BACKPLANE POWER

DISTRIBUTION SYSTEM

# PROPOSED AMENDMENT TO THE DRAWING

#### **AMENDMENT UNDER 37 CFR 1.121**

#### Figure 1

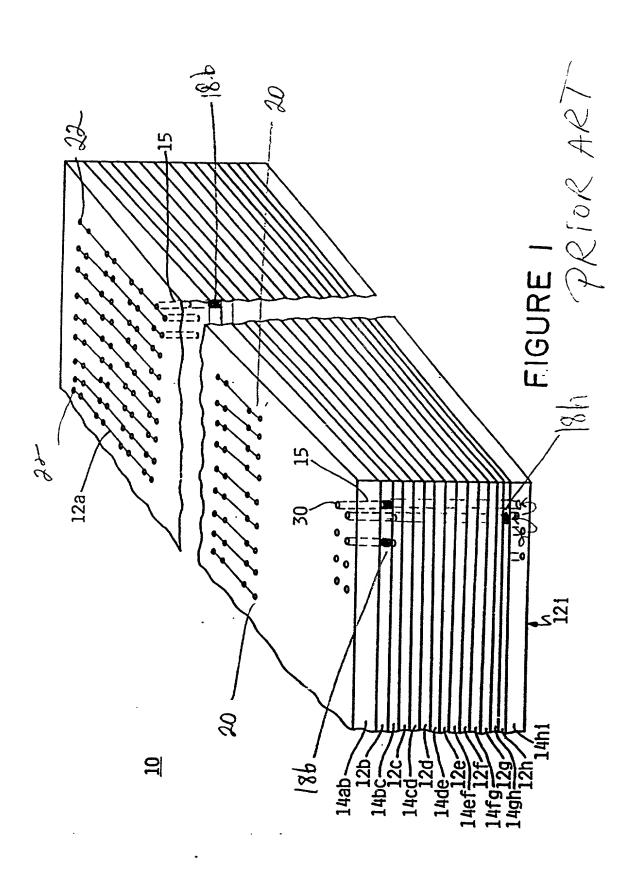
Please extend the pointers from reference numbers 18b and 18h as indicated. Please delete the circles and extensions from layer 14hi as indicated.

the pointer from reference numbers 18b and 18h now reach their destinations;

the extraneous material from layer 14hi at the bottom of the page has been deleted;

reference number 12a is shown slightly above the center of the page; references to pins in Figure 1 has been changed in the specification at applicable occurrences to references to locations.

FIGURE 2

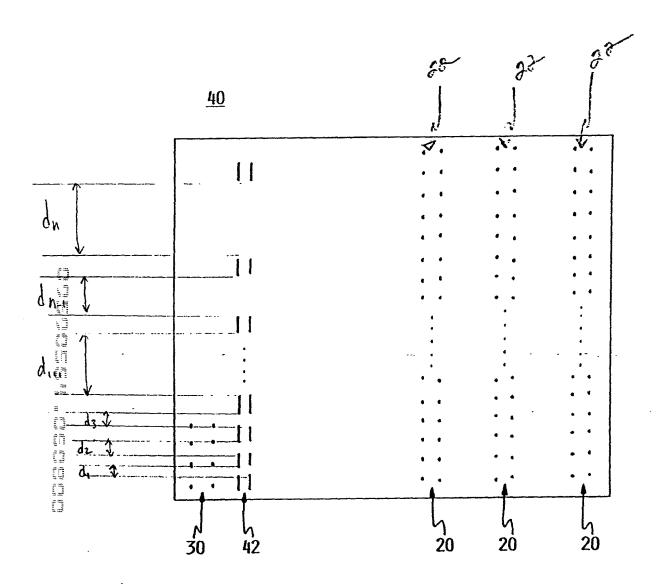
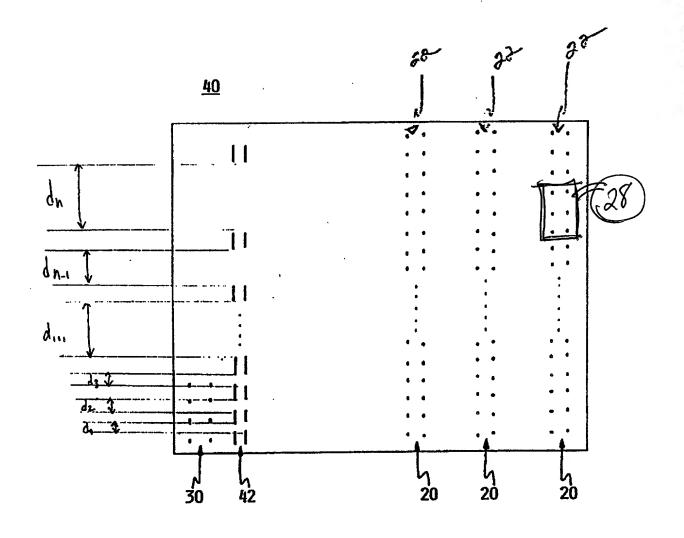
Please insert a rectangular block with a lead line to a reference numeral 28, as shown.

a rectangular block, a pointer, and a reference numeral 28 has been added representing connector straps or pads, wiring networks, etc. as described in the specification at page 4, lines 23-24 and in claim 11.

The Examiner states that the connector straps and pads of claim 11 are not shown. Figure 2 and its description in the specification have been amended to shown connector straps or pads, wiring networks, etc. 28. By amending Figure 2 and the specification, applicants have not added new matter. Connector straps and pad were in the originally filed specification of the parent application on page 5, line 32 through page 6, line 1 and in the specification filed of this application on page 4, lines 23-24. Conventional features disclosed in the description and claims, where their detailed illustration is not essential for a proper understanding of the invention, should be illustrated in the drawing in the form of a graphical drawing symbol or a labeled representation (e.g., a labeled rectangular box). 37 CFR 1.83(a).

Figure 3

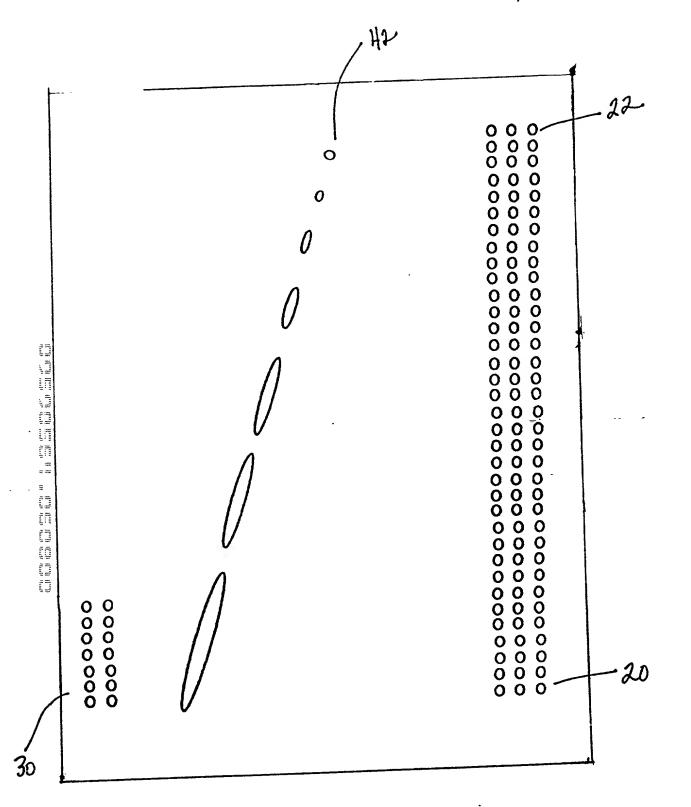
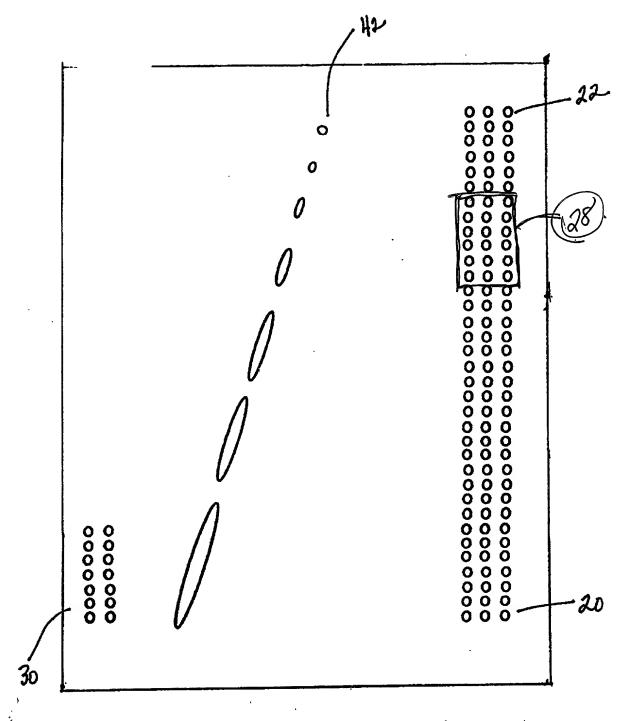
Please insert a rectangular block with a lead line to a reference numeral 28, as shown.

a rectangular block, a pointer, and a reference numeral 28 has been added representing connector straps or pads, wiring networks, etc. as described in the specification at page 4, lines 23-24 and in claim 11.

## Figure 4

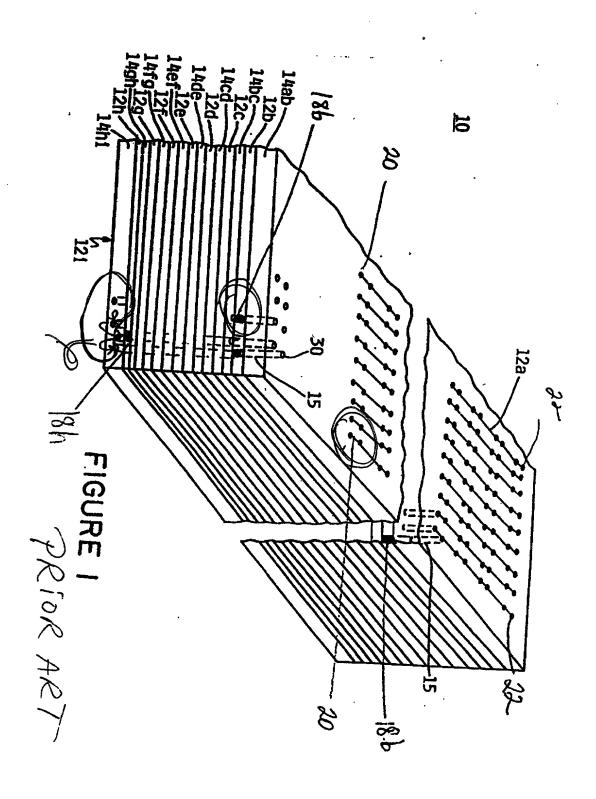
Please insert and extend the edges of the powerplane 40 so the lower right-hand portion of the figure is not cut off.

Please delete the black shading from the impedance variations 42 at the left third of the page and at the far load locations 22 towards the top of the page, without disclaimer or prejudice.

Please insert lead lines from the reference numeral 20 to the holes on powerplane as indicated.

Please insert lead lines from the reference numeral 22 to the holes on powerplane as indicated.

Please insert lead lines from the reference numeral 30 to the holes on powerplane as indicated.

the edges of the powerplane 40 have been inserted and extended so that the lower right-hand portion of the figure is not cut off;

the coloring of the impedance variations and load locations of Figure 4 has been deleted. In doing so, however, Applicants maintain that the impedance variations 42 are not limited to the geometric openings presented but can be openings of different shapes and/or material of different resistivity than that of powerplane 40;

pointer lines have been inserted from reference numerals 20, 22, and 30 to the different holes on the powerplane;

the Examiner states that it is unclear what the shapes of 20 and 22 are. Respectfully, the specification states that the source locations (30) and load locations (20 and 22) be capable of receiving pins. The shape of the pins is not disclosed in the specification and it is known in the art that connector pins come in all kinds of shapes; circular, oval, octagonal, flat, etc. Applicants respectfully decline to limit the invention to a particular rendition and maintain that the source locations and the load locations are the same part as referenced in Figures 2, 3, and 4.
